MEETING MINUTES

Subject: 222-S Laboratory Secondary Containment Upgrades - Project W-087/W-178 Status and Issue Clarification

Attachment 2
Photograph of Drain Valve in T-8 Tunnel

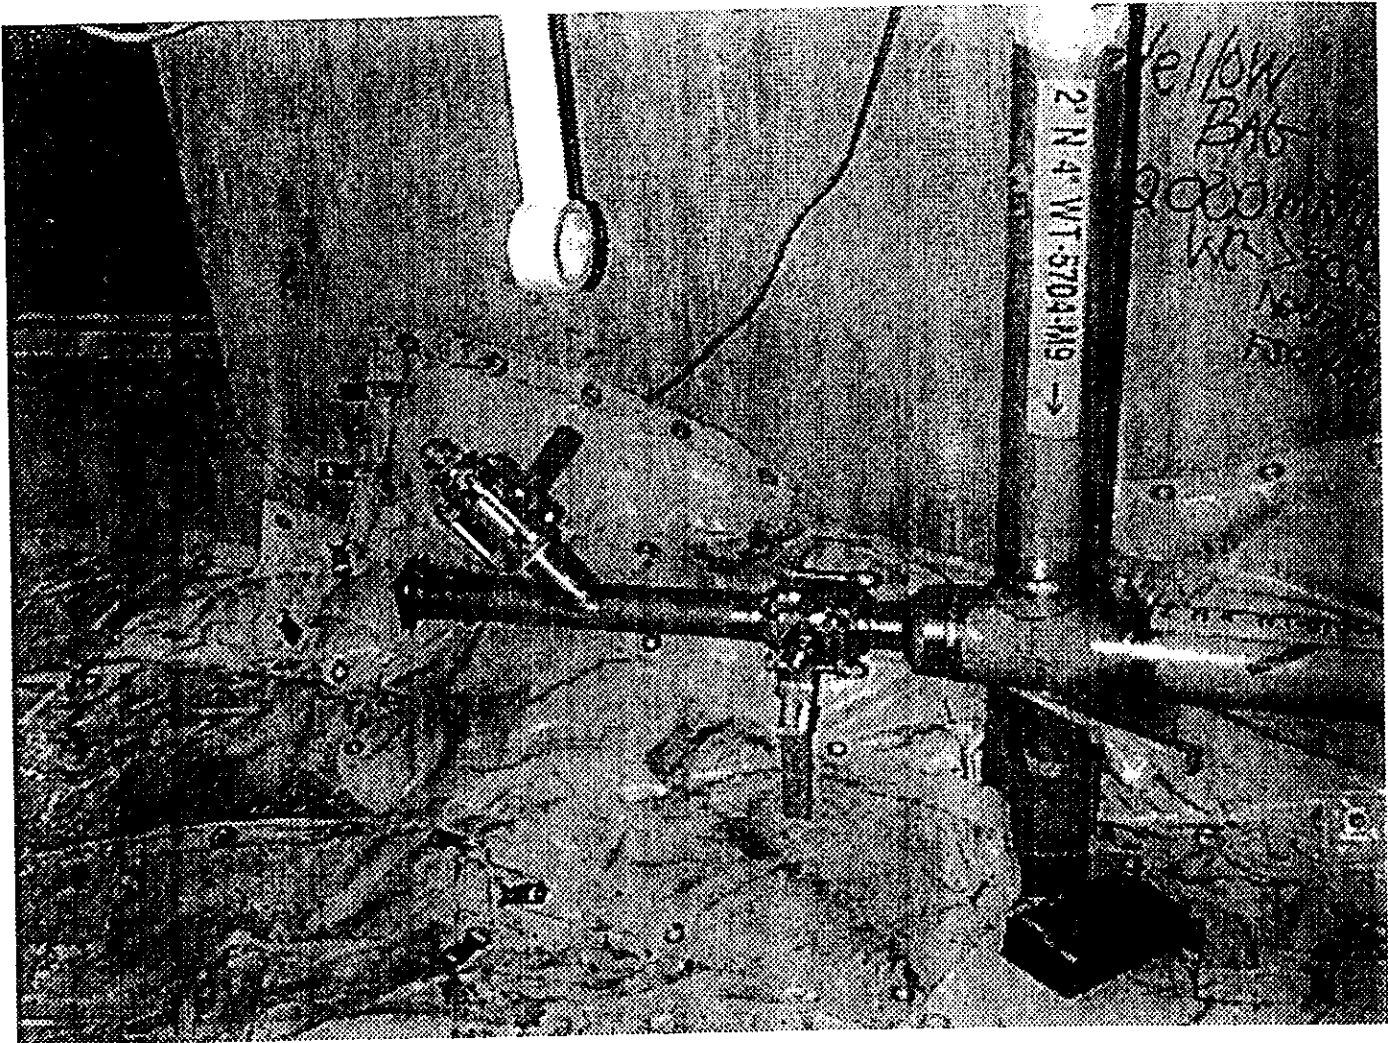
Mr. Beyer and Mr. Cahill showed Ms. Huckaby a photograph of a valve in the T-8 tunnel that they propose leaving installed for purposes of flushing the new process lines to lower radiation dose (Attachment 2). The new drain header is gravity-feed only, slopes away from the valve location, and leaves approximately 2" of the pipe (which is normally empty) without secondary containment. This section of pipe is located upstream of the normal flow and would therefore have limited contact with waste during routine operations. The potential exists for high-radiation dose residual solids from laboratory operations (e.g., tank farm samples from hot cells) to settle in the line, resulting in a significant increase in dose in the area. Should this occur, the process lines would be flushed via the valve. Experience has shown the benefit of being able to flush the line for dose reduction. The valve would provide an access point for pipe cleaning which would be of value for maintenance. Ms. Huckaby asked what sort of secondary containment, if any, would be provided. Mr. Cahill stated that because the potential for a leak was so small, none was planned and that the very low potential for any type of failure is far outweighed by the value of having this flush port available. It was concluded that concurrence would be sought from the independent qualified registered professional engineer (IQRPE) documenting the "value" versus "risk" in the assessment. Ms. Huckaby agreed with the recommendation, pending concurrence of the IQRPE in the assessment.
